#### Flooding and Drainage Issues

# Main Electrical Rooms for South Tower exposed to flooding because of poor drainage

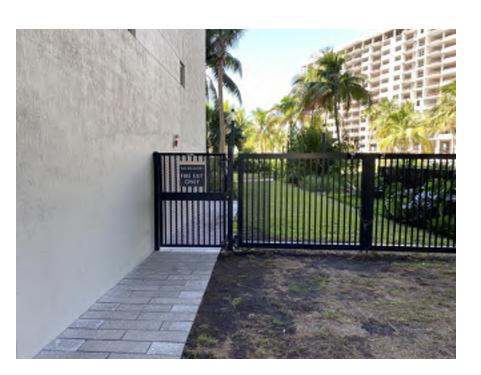
Vegetation visually obstructing commercial units in south tower by dog park. Dog park proposed in project drawings for north tower is much smaller and is supposed to cater to three times the amount of residents, please reference project drawings in pdf attachment.
